E	12/03/12	Section 75W Submission	PL	MD
D	04/11/11	Revised Design following SOPA comments	JC	MD
B	09/09/11	Revised Design following SOPA comments	MD	MD
A	06/04/11	DA Submission	JL	MD
Revision	Date	Description	Initial	Checked

Site 3
Sydney Olympic Park
Plan
Basement 001

Site 3
Sydney Olympic Park
Section BB

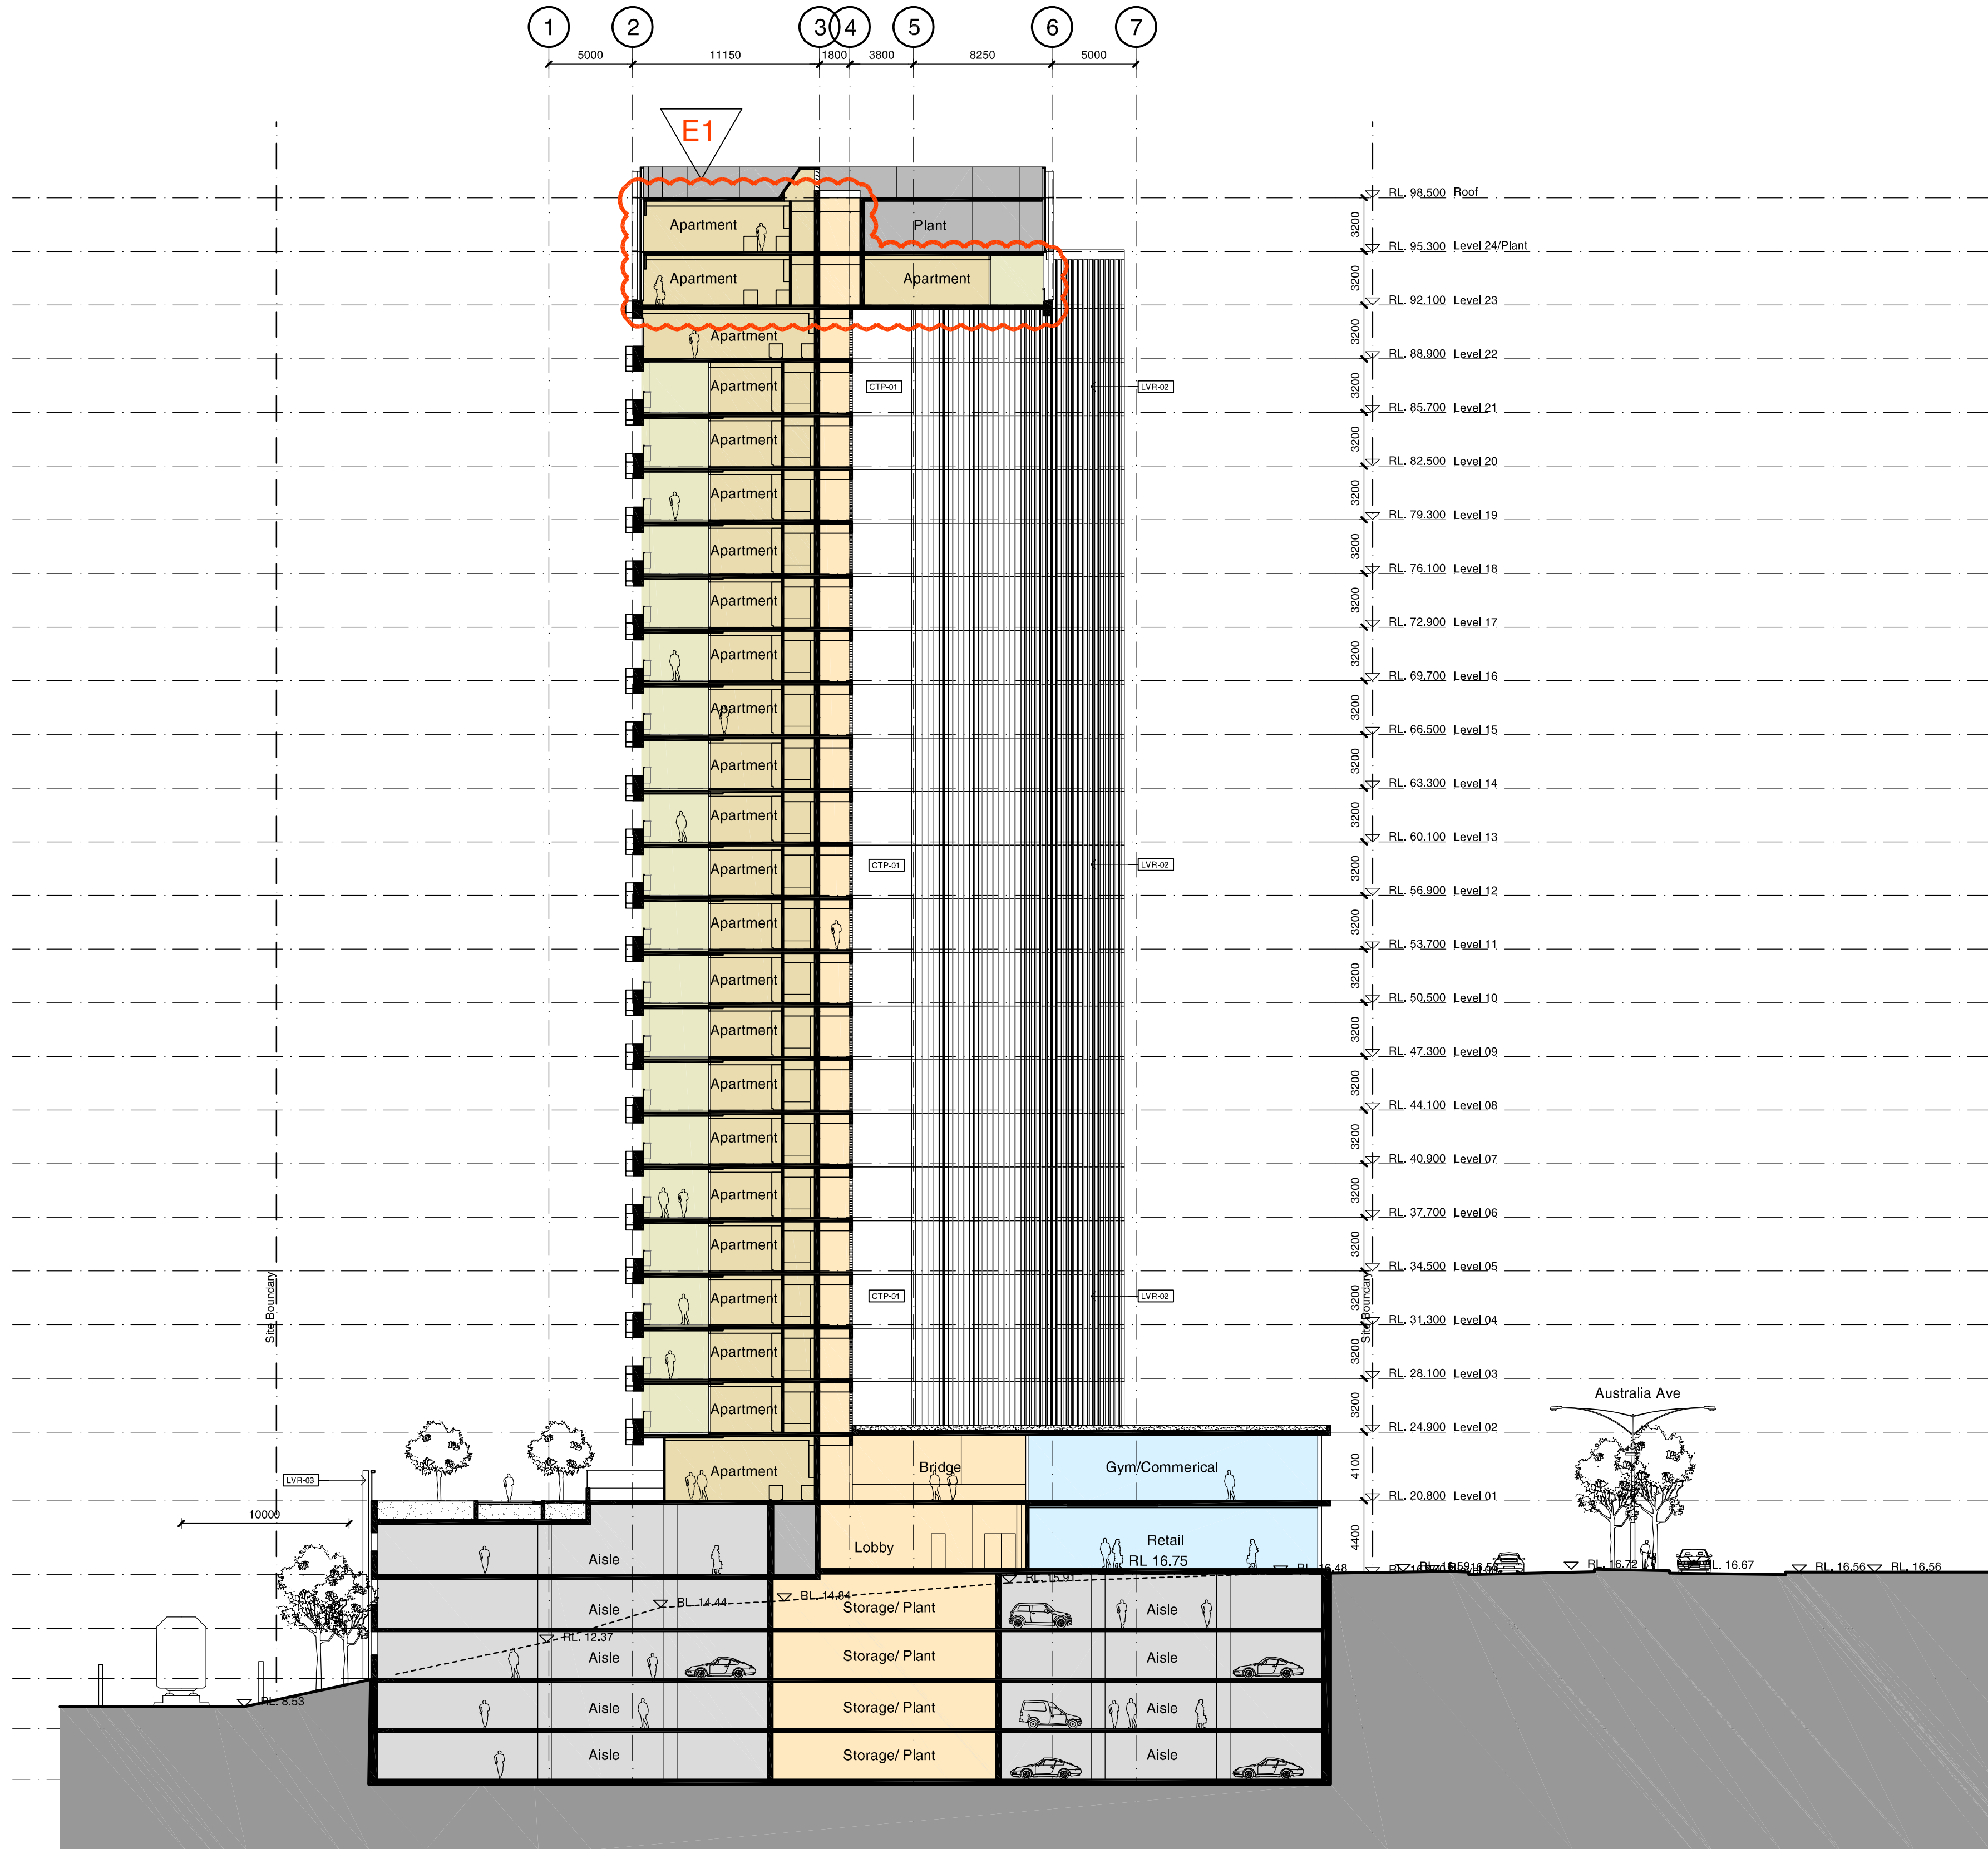
Revision E - Section 75W Amendments.
1. Loft apartments modified to single storey apartments on Level 23 & 24.
